May 29, 2018

**R E :                Château Laurier – ERA Project No. 17-058-02**

Heritage Memo – Revised Cultural Heritage Impact Statement Addendum

EAST ELEVATION

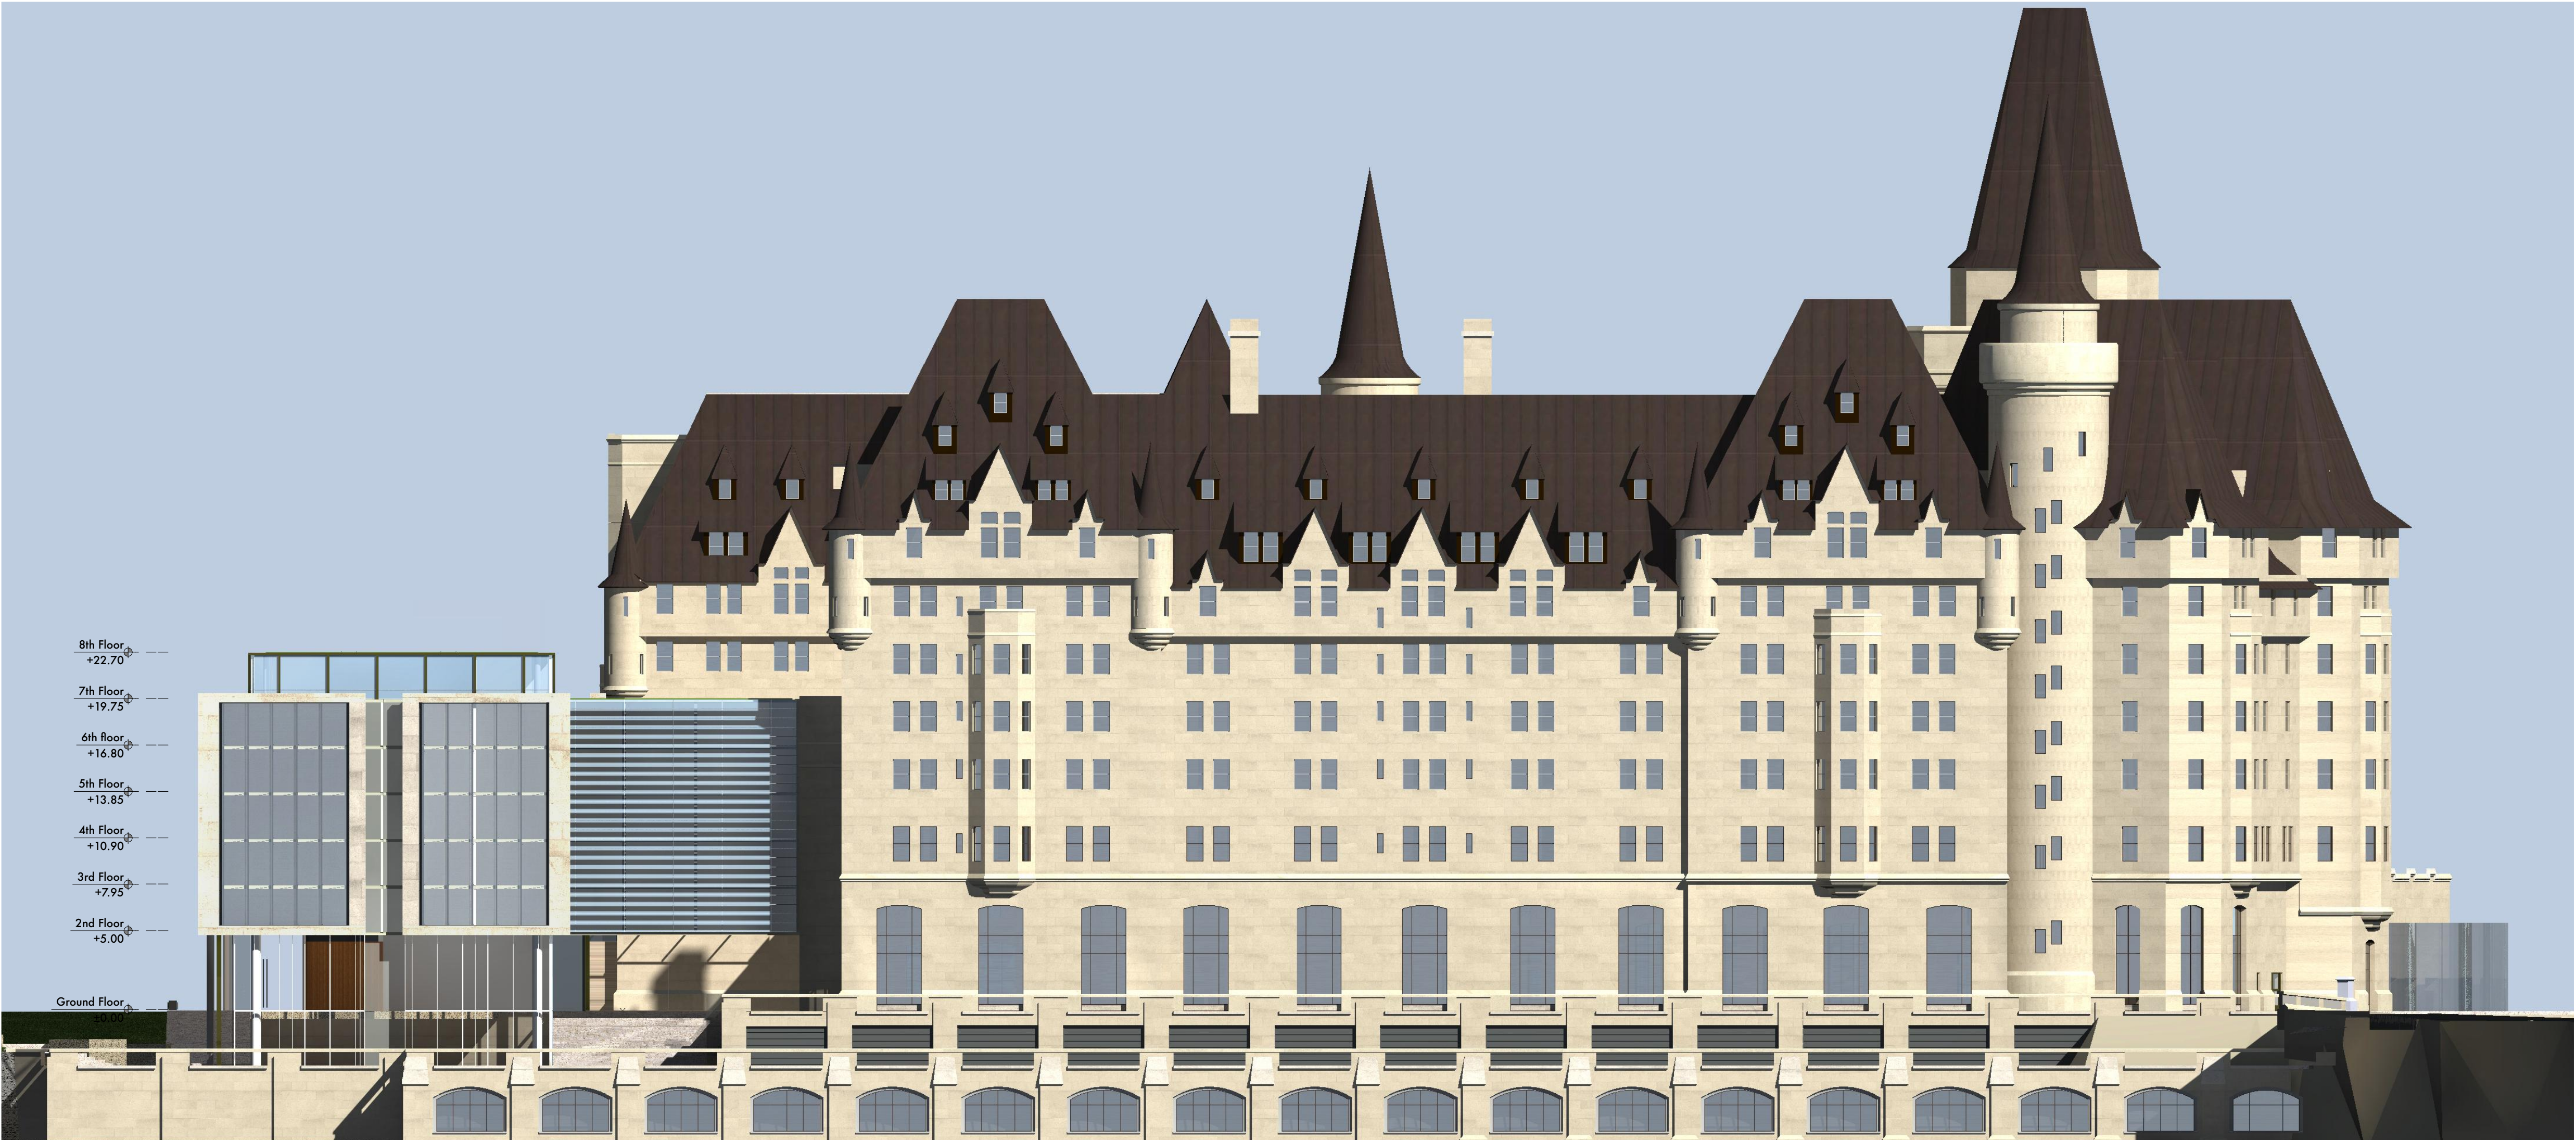
- The exterior expression of the addition's east façade, facing McKenzie Ave, has also been refined; as the previous treatment, which featured diagonal stone planes within a stone frame, was found to be too heavy and oppositional to surrounding heritage buildings along McKenzie avenue, this elevation has been redesigned to feature lighter diagonal glass planes within a limestone frame;
- The exterior expression of the addition's west façade, facing the Rideau Canal, has also been refined; as the previous treatment, which featured diagonal stone planes within a stone frame, was found to be too heavy and incompatible with the surrounding context of built and landscape features, this elevation has been redesigned to feature lighter diagonal glass planes within a limestone frame.

It is our opinion that, from a heritage perspective, the exterior refinements described above represent a positive and context-sensitive design evolution for the Château Laurier's proposed addition. As such, the assessment and conclusions presented in our previous Revised CHIS Addendum, dated May 9<sup>th</sup>, 2018 - that the proposal conserves the cultural heritage values and attributes of on-site and adjacent heritage properties, as well as the cultural heritage value and character of the surrounding cultural heritage landscape - remain unchanged.

NORTH ELEVATION  
SCALE: 1:200

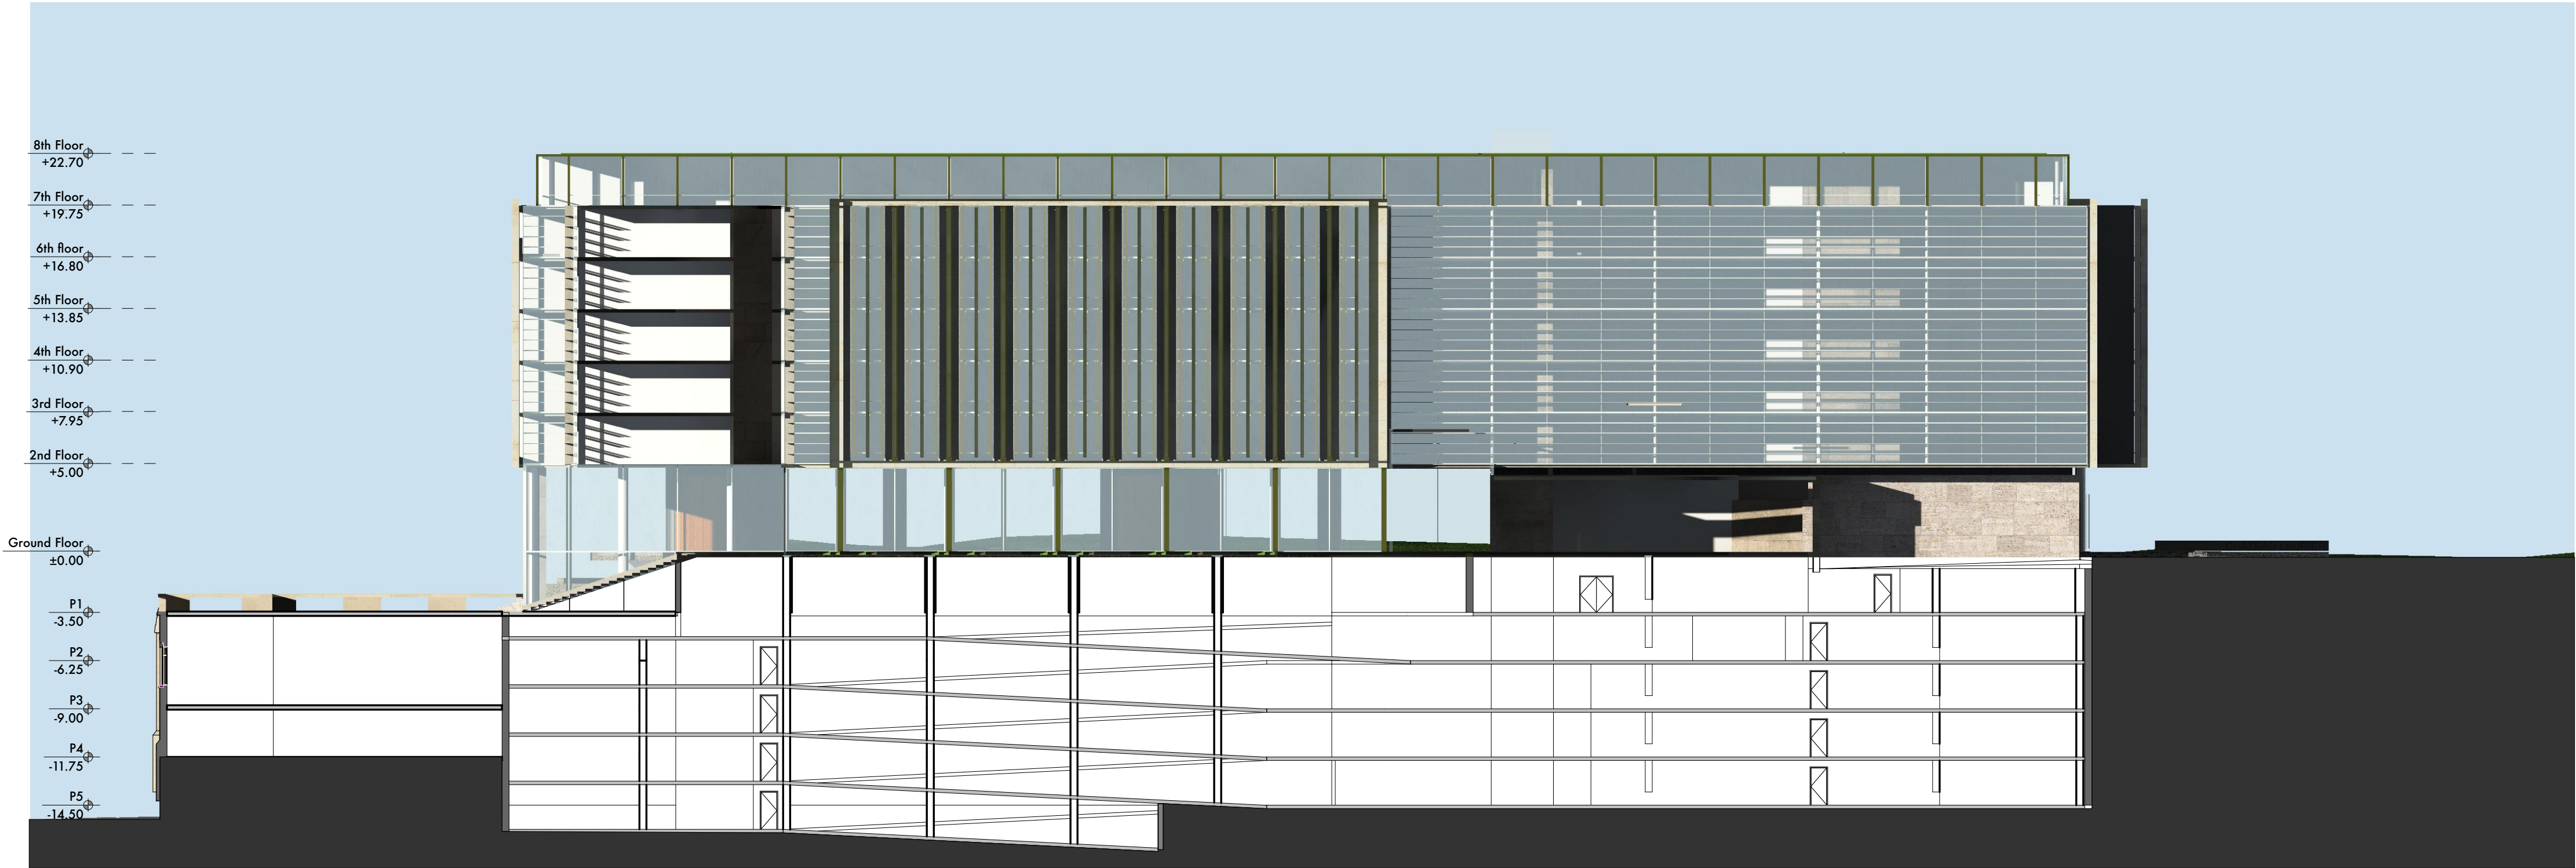
- The exterior expression of the addition's north (park-facing) façade has been refined; the new design features a more refined tripartite expression (as was the case with the previous design

iteration) overlaying a varied pattern of limestone fins to break up and add visual interest to this long elevation;
